Appendix A

Agency Coordination

TORONTO
POWER PLANT

Re: Request for Input for the Proposed Toronto Power Plant

PREVIOUSLY RECORDED SITES AND SURVEYS

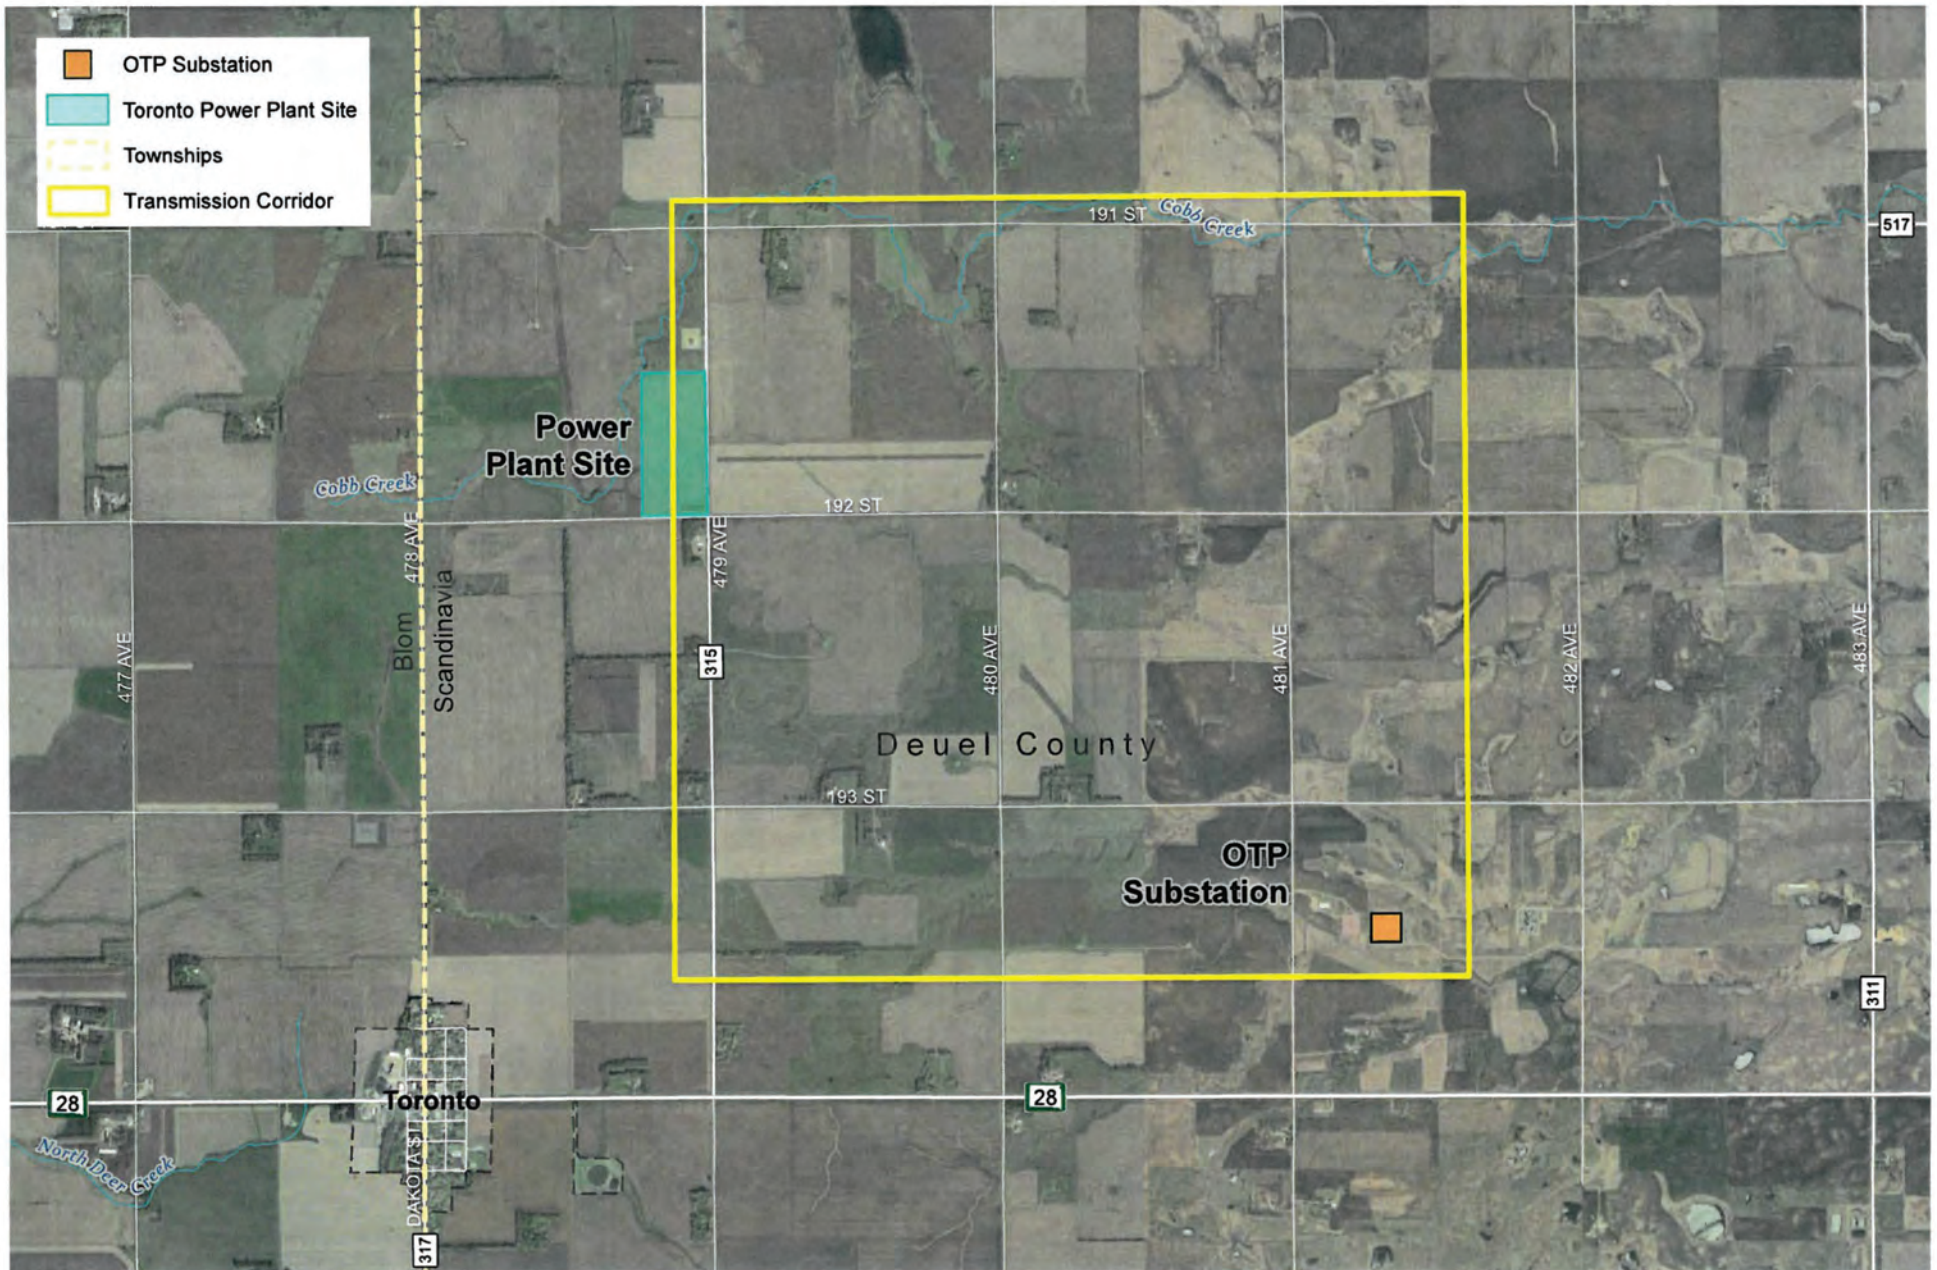
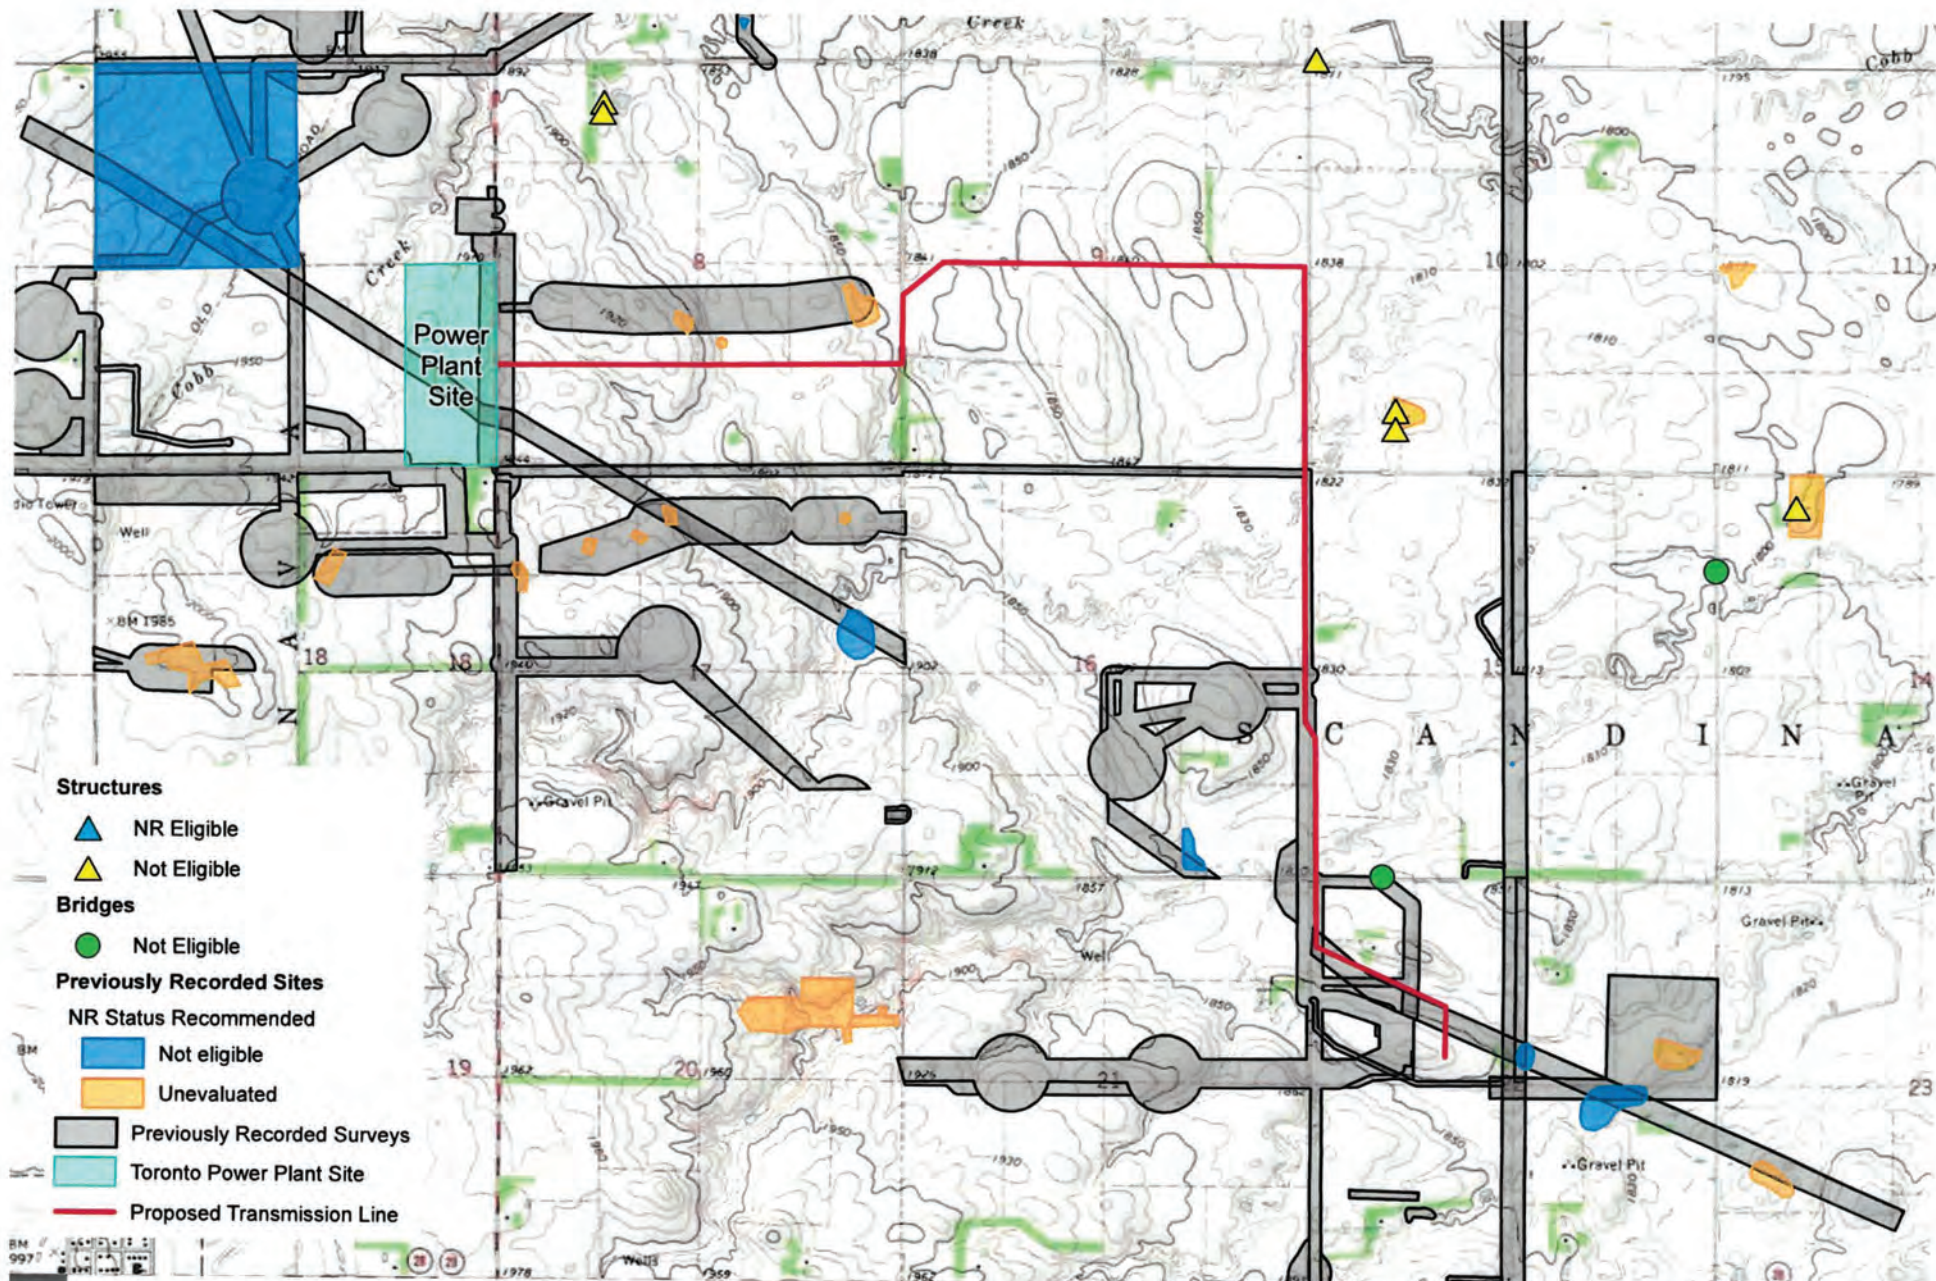
On September 13, 2024, SHPO received your letter, dated September 11, 2024, a map of the proposed project locations, a figure displaying the results of the record search, and documentation of tribal consultation regarding the proposed Toronto Power Plant and Transmission Line project. On September 13, 2024, SHPO requested additional information to clarify if the proposed project was to be reviewed under Section 106 of the National Historic Preservation Act of 1966 (as amended) or, if the proposed project was seeking a permit from the South Dakota Public Utilities Commission (PUC), would need to be reviewed under SDCL 1-19A-11.1. On September 19, 2024, SHPO received an email from Becky Baker of HDR, Inc. who clarified that the proposed project currently has no federal involvement and would be subject to SDCL 1-19A-11.1 as they would require an Energy Conversion Facility Public Utility Commission permit.

1. Provide a copy of the original official record search from the Archaeological Research Center that identifies the previously recorded cultural resources within one mile of the proposed project area.
2. Have a qualified archaeologist complete an intensive field survey of the project area.

3. Conduct an analysis of the visual effects of the power plant and transmission line on cultural resources within one mile of the project area.

1. Provide a copy of the original official record search from the Archaeological Research Center that identifies the previously recorded cultural resources within one mile of the proposed project area.
A record search was completed by Augustana as part of the Level III survey and report. A background record search revealed that five cultural resource investigations were previously conducted within one mile of the project area; three of these investigations intersect the project parcel. The records search further revealed that 15 archaeological sites and 16 structures are recorded within one mile of the project area; none of these are within the project parcel (power plant site).

2. Have a qualified archaeologist complete an intensive field survey of the project area.
A Level III survey and report were completed for the power plant site. The report has been submitted on the SD portal. Historic maps and aerial imagery depict no evidence of structures within the project boundaries. Augustana documented a Native American isolate find and a lithic scatter (39DE0184 and 39DE0185) within the project area during the current investigation. Both sites were subjected to evaluative subsurface testing in an attempt to more clearly delimit their respective boundaries and ascertain their National Register of Historic Places (NRHP) eligibility status. Cultural deposits associated with both sites are confined to disturbed surface contexts and the landform harboring these sites has been wholly deflated. Augustana recommends that both sites be considered not eligible for NRHP-listing.

3. Conduct an analysis of the visual effects of the power plant and transmission line on cultural resources within one mile of the project area.
Augustana conducted a viewshed analysis within a one-mile-radius of the project area. Within this range, two unevaluated Native American artifact scatter sites, 39DE108 and 39DE112, fall within the viewshed. Aboveground infrastructure associated with the proposed project has the potential to negatively impact the NRHP eligibility status of these properties provided they are determined eligible for NRHP-listing.

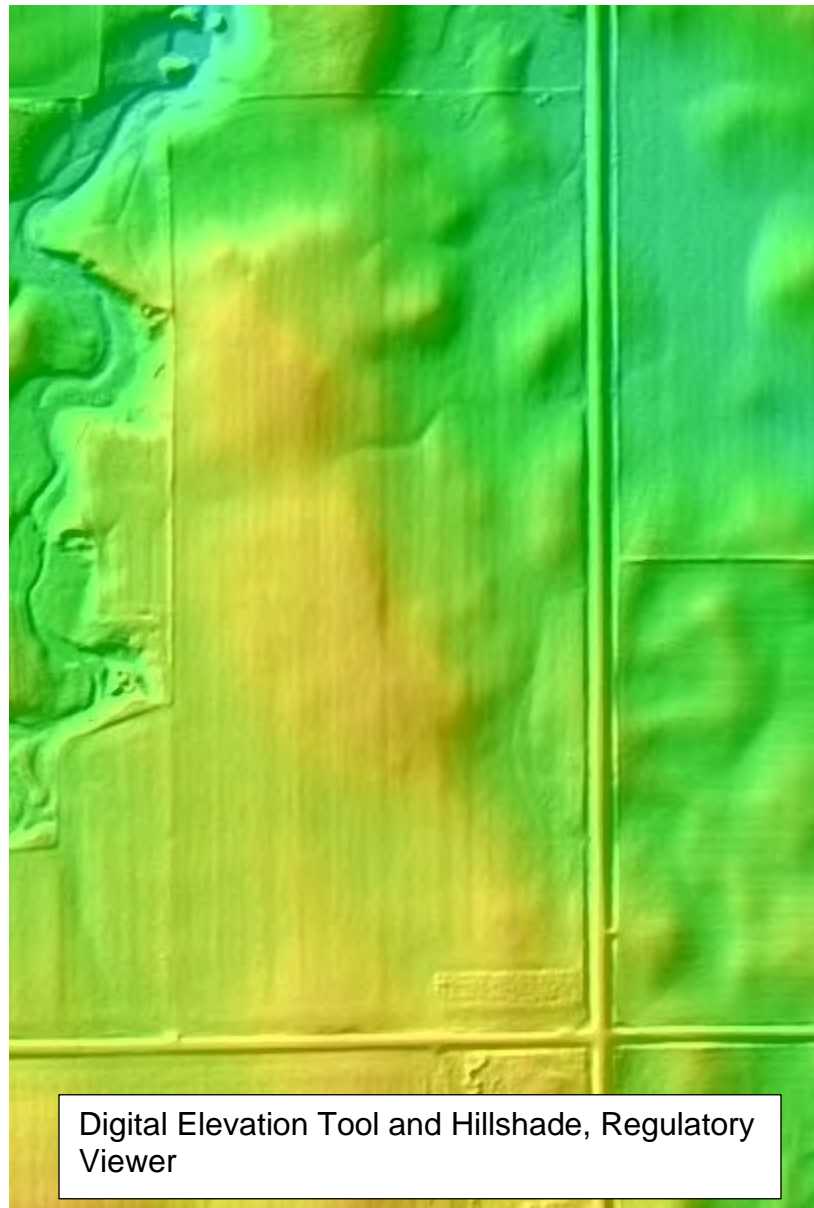
[Wetland 1 is 2.31 acres situated in hayed agricultural lands. It is a depressional feature that is bordered by uplands as well as County Road 315/479th Ave. It flows to the east towards the road, then north along the road ditch. Topography keeps water from this wetland basin from flowing west towards the nearest relatively permanent water. To the east, the wetland does not have a continuous surface connection to a requisite water.](#)

[Wetland 3 is 0.49 acres situated in hayed agricultural lands. It is a depressional feature that is bordered by uplands as well as County Road 315/479th Ave. It flows to the north and east towards the Tatonka O&M Building, then north along the road ditch. Topography keeps water from this wetland basin from flowing west towards the nearest relatively permanent water. To the east, the wetland does not have a continuous surface connection to a requisite water.](#)

[Wetland 4 is 3.18 acres situated in hayed agricultural lands. It is a depressional feature that is bordered by uplands as well as County Road 315/479th Ave. It](#)

flows to the north and east towards the road, then north along the road ditch. Topography keeps water from this wetland basin from flowing west towards the nearest relatively permanent water. To the east, the wetland does not have a continuous surface connection to a requisite water.

Wetlands 1,3, and 4 were determined to be non-jurisdictional because they do not meet one or more categories of waters of the United States under the pre-2015 regulatory regime consistent with the Supreme Court's decision in *Sackett*, since Wetland 1, 3 and 4 are non-tidal wetland that does not have a continuous surface connection to a jurisdictional water.
